HOMELITEA DIVISION OF
TEXTRON INC.

SUBJECT: Sprocket Keys and Clutch Spider Keys

DATE: 1/7/58

SUBJECT: New Exhaust Cap (56396)
New Heat Damper (55506-A)

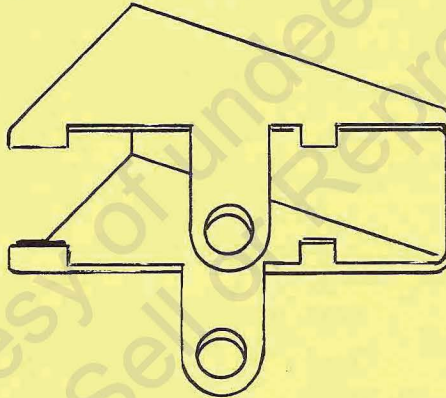
A new and improved method for assembling the muffler on 7-19 and 7-21 chain saws has gone into effect.

1. The four 6-32 tapped holes in the cylinder exhaust flange have been eliminated -- they are no longer needed. The cylinder part number changes to 56182-A.
2. A new exhaust cap Part No. 56396, made of steel, replaces Part No. 55507.

The new cap is held by the same two screws which fasten the heat damper.

3. To provide proper clearance the heat damper casting has been revised. Heat damper Part No. 55506-A must be used with the new exhaust cap.

The new parts can be installed on saws now in the field, provided these saws are equipped with a cylinder which contains the 10-32 threads for the two heat damper screws.

SUBJECT: Fuel Outlet Fitting, Part No. 55572-A

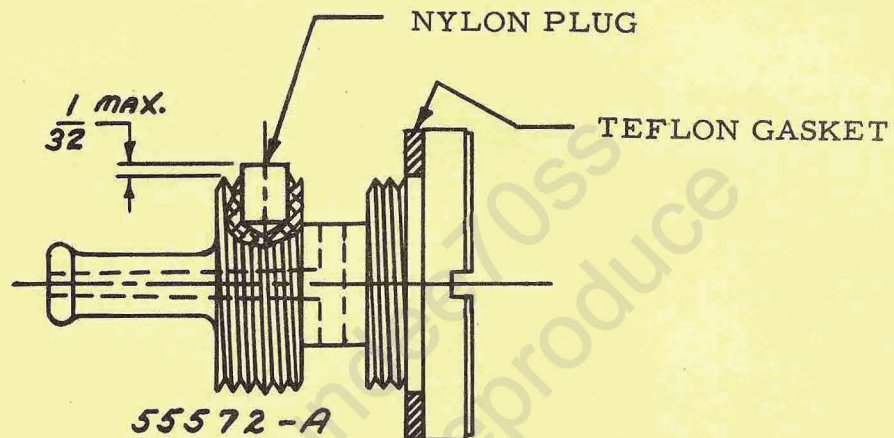
The sketch above shows the new Fuel Outlet Fitting #55572-A which supersedes 55572 in Homelite Direct Drive Chain Saws. The Nylon Plug is new and has been added to provide a seal on the inner thread.

When the saw is used in the "Right-Hand Felling" position the outlet fitting is not covered by fuel -- instead it is surrounded by the air in the fuel tank. If part of this air is drawn around the threads it enters the fuel supply line, leans out the mixture and may stall the engine. You may think that the carburetor has "gone out of adjustment".

The nylon plug prevents this difficulty. Use Outlet Fitting No. 55572-A for all replacements.

SUBJECT: Sprocket Shaft Bearing

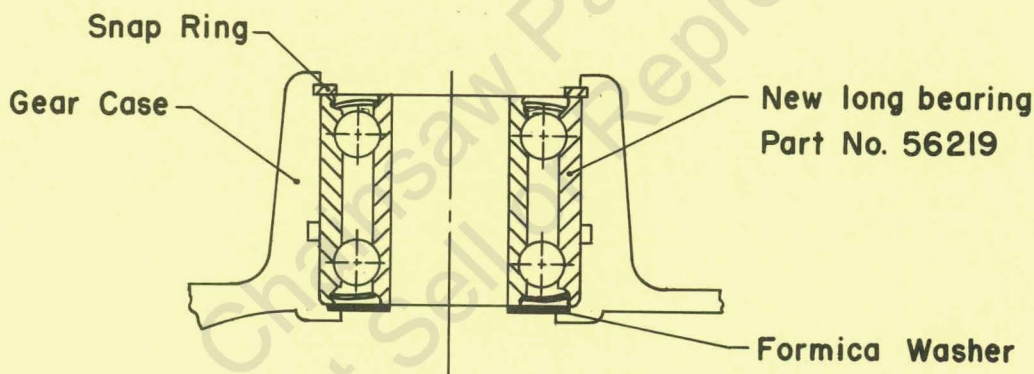
We have been able to procure a single, long Double Row Ball Bearing to replace the narrow ball bearing and roller bearing combination used formerly to support the sprocket shaft in 6-22 and 7-21 chain saws.

The new bearing carries part number 56219. It is permanently lubricated and sealed; for this reason it is no longer necessary to use Lubriplate in the groove of the Gear case.

After you use up your stock of 72040 ball bearing and 56073 roller bearings, use new bearing 56219 for all replacements.
